SERVICE BULLETIN

SVR 09-001 Rev.

Product: **All 2008 Honey Bee WS Grain Belt Swathers**

Re: Roller and Tension Issues

Required parts

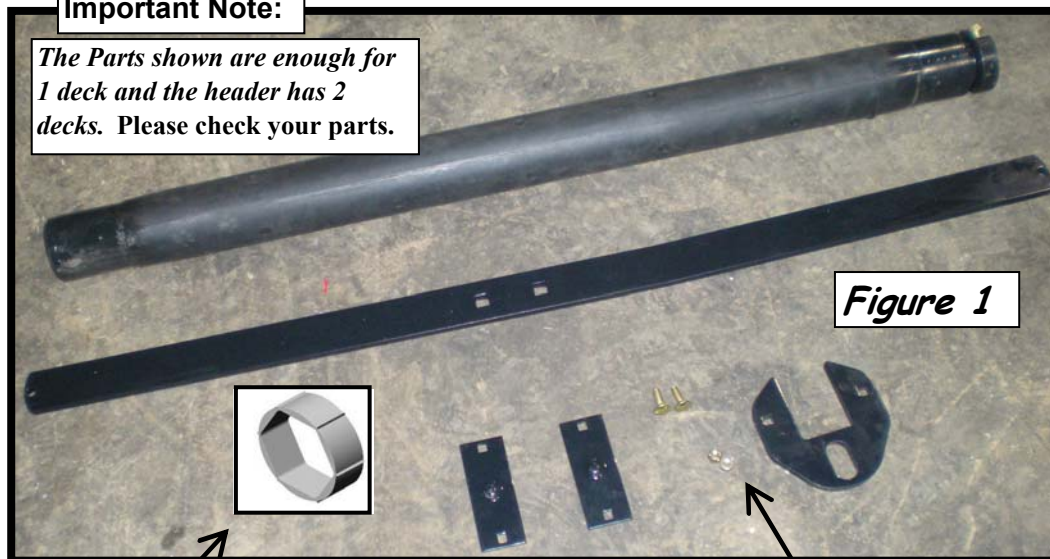
- Problem:**
- 1) Under heavy load the draper slips on the roller and must be over tightened to maintain performance, excessive tightening may result in premature draper failure. such as excessive stress on motors, bearings, adjusters and eventually drapers.
 - 2) The current sway bar which assists in draper tensioning and alignment, restricts draper movement and may also cause draper damage
 - 3) Excessive play in idler roller.

Solution: Replace Draper drive roller, Sway bar, add Sway bar hardware and up date Idle roller.

Qty.	Part #'s	Description
2	81312	Vulcanized drive roller
2	81414	Sway Bar Mount tab kit
2	G81586	Sway Bar-draper dk/bent
2	81585	<u>Insert</u> to Idle roller to adapt to Hex bearing mount
1	19748	Bolt carriage head 1/2 X 1-3/4 (used to install Hex Insert)
1	94308	Instruction package

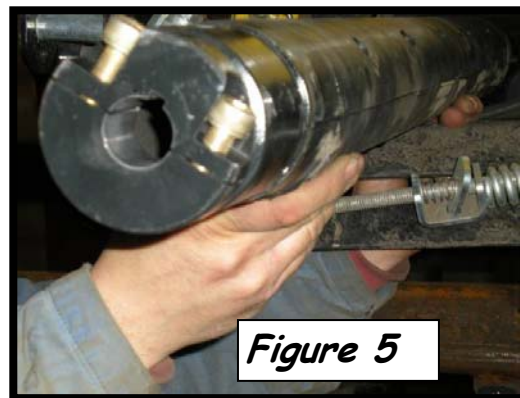
Step 2 Locate Hyd. Deck Motor and loosen the 2 set screws that attach motor to the roller.
Figure 2

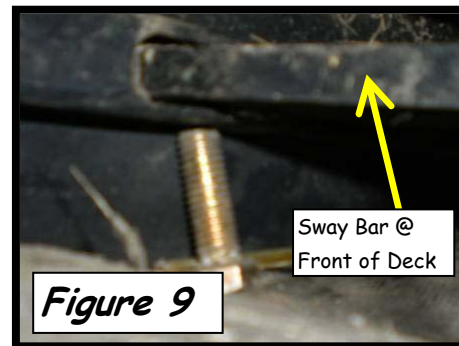
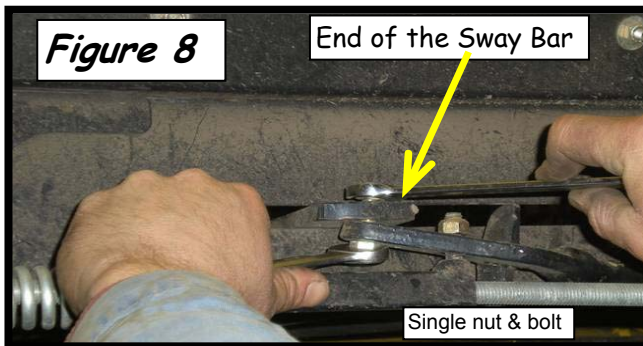
- Step 7** Install existing Hyd. Deck Motor onto the Valcanized Drive Roller until the V groove on roller is aligned with deck guide. **Figure 7**

- Step 8** Tighten the cap screws **evenly**, alternating back and forth until **tight**.
Set the final **Torque** to **40 ft/lbs.** or **55 nm**.
Refer to **Figure 2 &/or Figure 6** for view of the set screws.

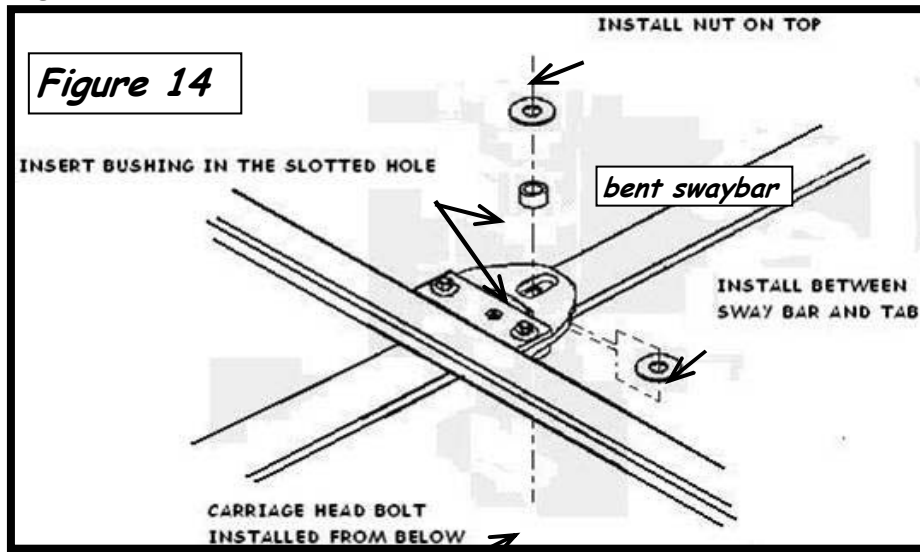
- Step 13** Assemble the New Mount Tab Kit to existing sway bar mount tab, hardware supplied.
Note: The new tab provide a more effective pivot point for the sway bar.
Figures 12 and 13

- Step 14** Install bent sway bar to mount tab with existing hardware (bar is intentionally bent).
Make certain the *ends of the swaybar are higher than the center point*.
Figures 14 and 15

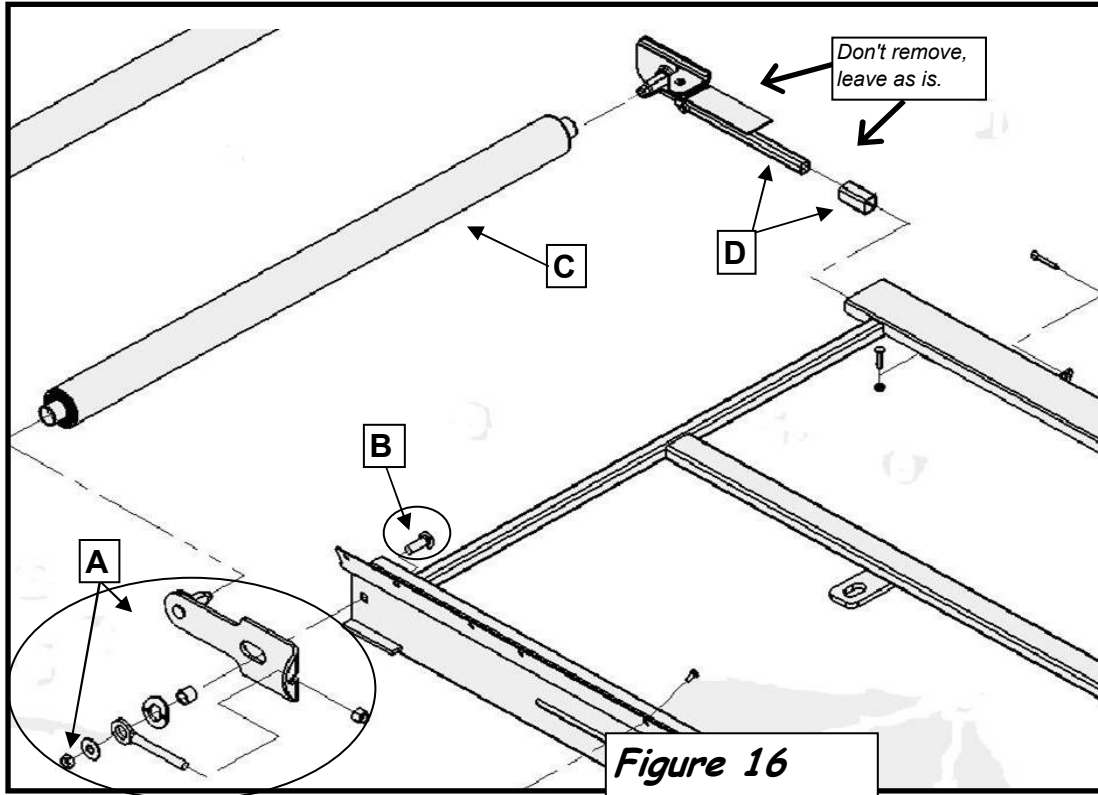
- Step 17** Remove the nut that holds the Idler roller in position.
Keep the assembly referred to as **A** in **Figure 16**, together for ease and speed of reassembly.

- Step 18** The idler roller can now be removed.
Note the idler roller is labeled C and must be completely removed to install the insert.
Figure 16 & 17

Figure 18

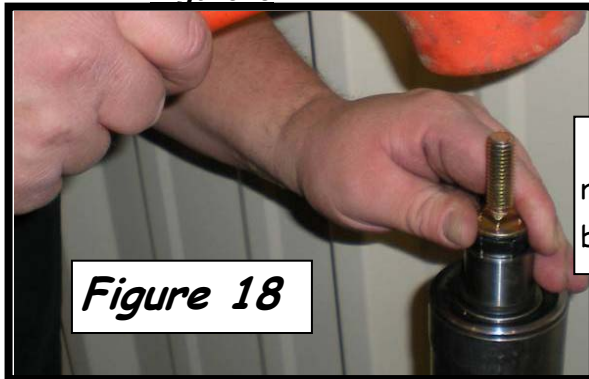
- Step 19** Place insert on roller end and start by hand.
- Step 20** Position the Carr. bolt on the exposed end of the insert, tap until insert is recessed approx. 1/4".

The **Insert** should be recessed into the roller about **1/4"** and should be **driven** in by **tapping** rather than **hammering**.

SERVICE BULLETIN 76-GBH

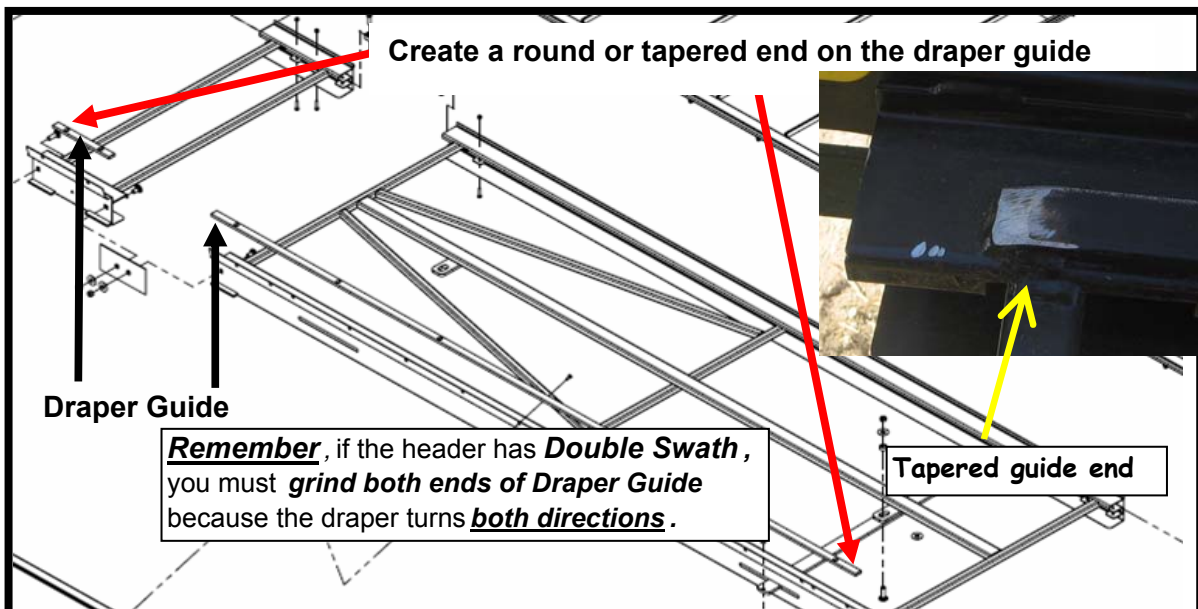
Problem: Excessive draper damage due to contact with V-guide ends.

Solution: Round off or taper the leading end of each of the draper tracking guides.
